CHANGE ORDER

No. 1-01

PROJECT: 2022 Capital Outlay Project OWNER: Ogdensburg City School District 1100 State Street Ogdensburg, New York 13669 CONTRACTOR: Barrett Paving Materials (Name, Address) 26572 NYS Rt. 37 Watertown, NY 13601 CONTRACT FOR: No. 1 - Site CONTRACT DATE: August 22, 2022	DATE OF ISSUANCE: November 2, 2022 ENGINEER: BCA Architects & Engineers 15 Public Square Watertown, New York 13601 ENGINEER'S PROJECT NO.: 2022-013 SED PROJ. MGR.: Wendy Clark SED CONTROL NO.: 51-23-00-01-0-006-013 John F. Kennedy
---	---

Re: **JC-L1 Additional Sidewalk**

JC-L1

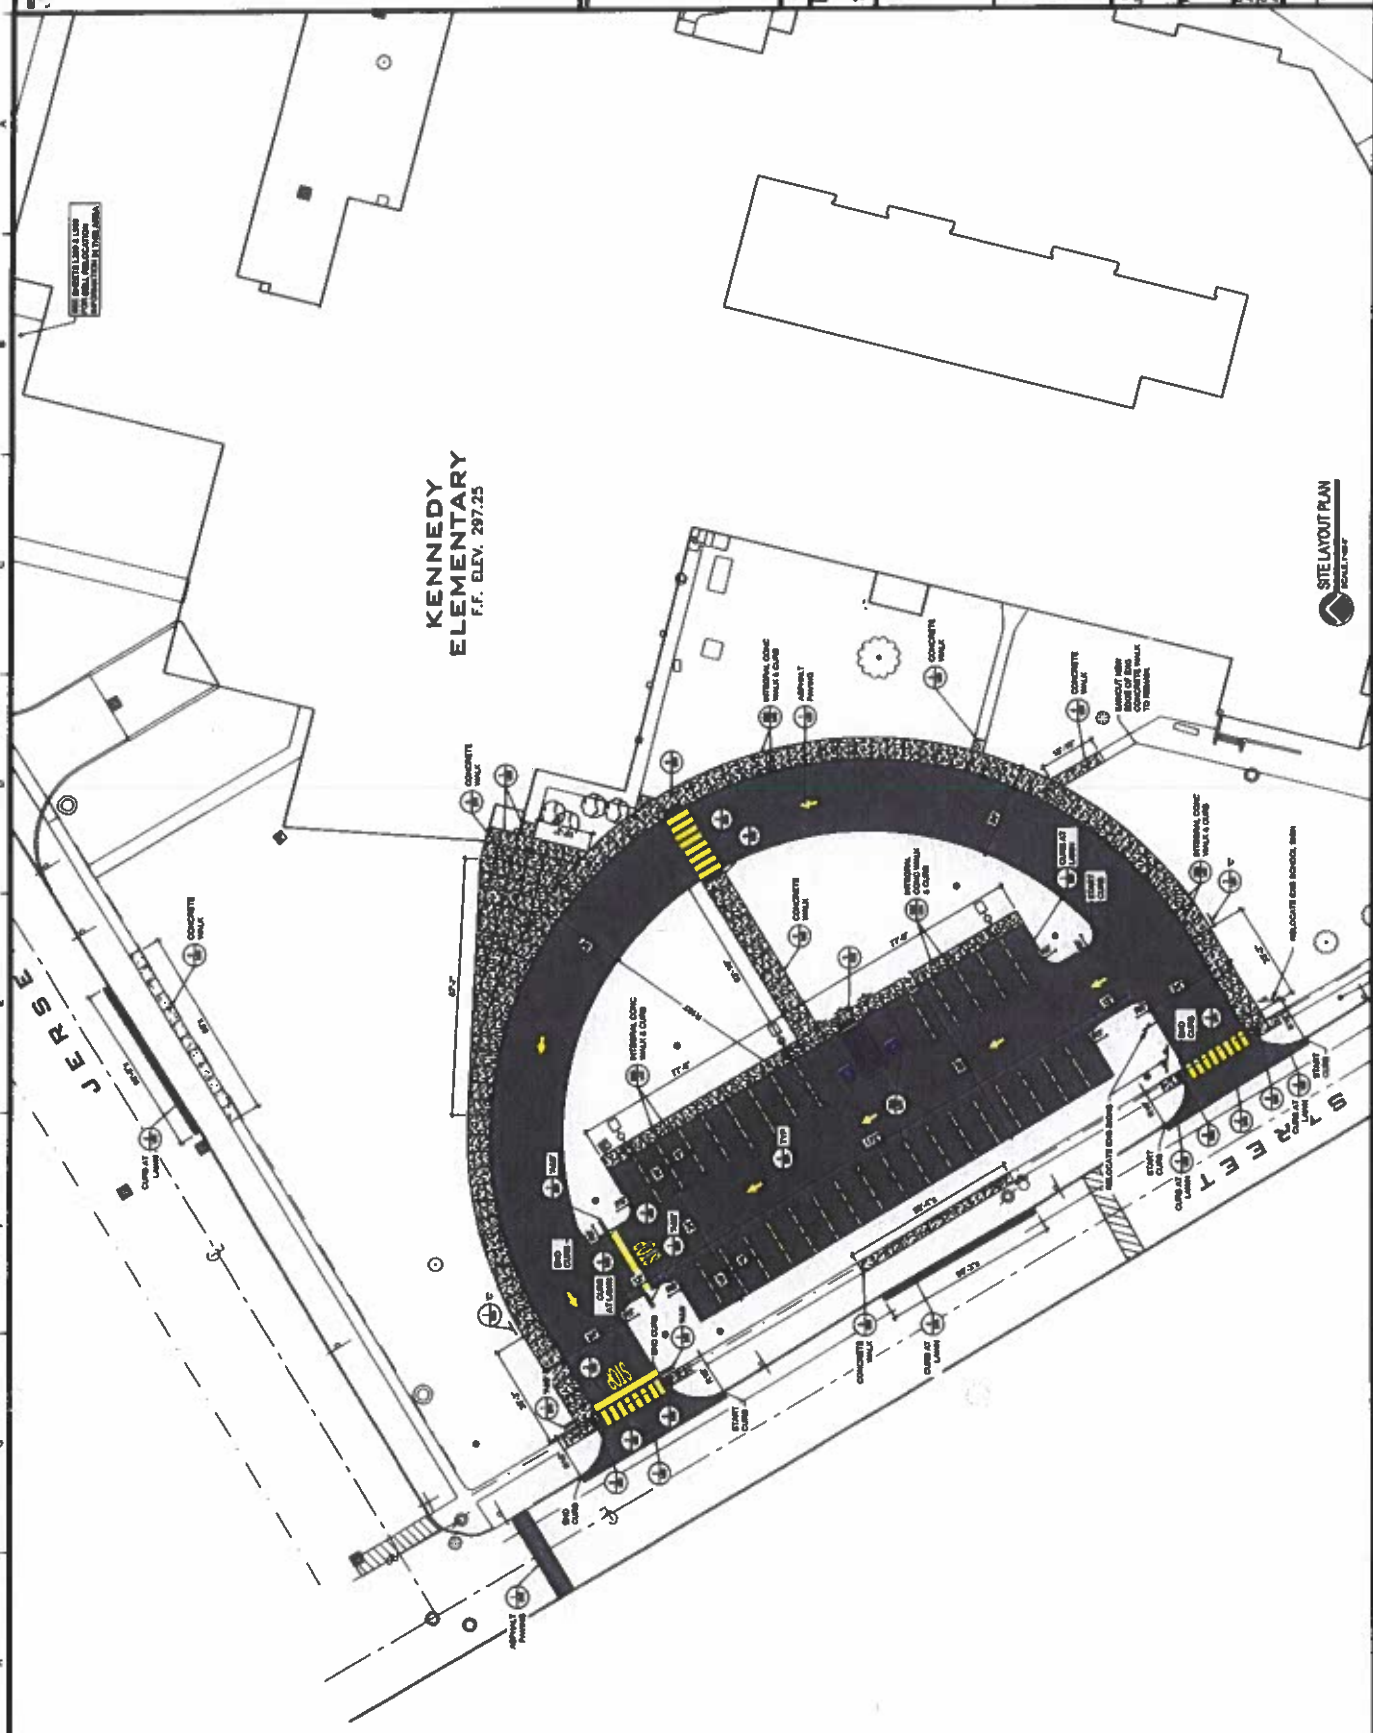
Add to provide an asphalt drive/walkway connection around the rear of the building to accommodate pedestrians as well as maintenance vehicles as per Contract Drawing JC-L1. \$ 33,844.50

Excavate approx. 155 CY, place 12 inches of Type 2 subbase on geotextile fabric. Finegrade area for asphalt. Pave area(327 SY) with 3.5" of Type 3 Binder Course HMA and 1.5" of Type 6 Top Course HMA. Apply Tackcoat between lifts. Topsoil Edges and seed disturbed areas.

C During construction, the Owner requested that an existing asphalt walkway / drive at the rear of the building be connected to the expanded playground area for students & staff coming from the south end of the building. The lack of a hard surface has resulted in a deteriorated, eroded path in the lawn from both vehicle & pedestrian traffic. With favorable bids and contractors already mobilized, work proceeded in accordance with Contract Drawing JC-L1.

D Add to provide an asphalt drive/walkway connection around the rear of the building to accommodate pedestrians as well as maintenance vehicles as per Contract Drawing JC-L1.
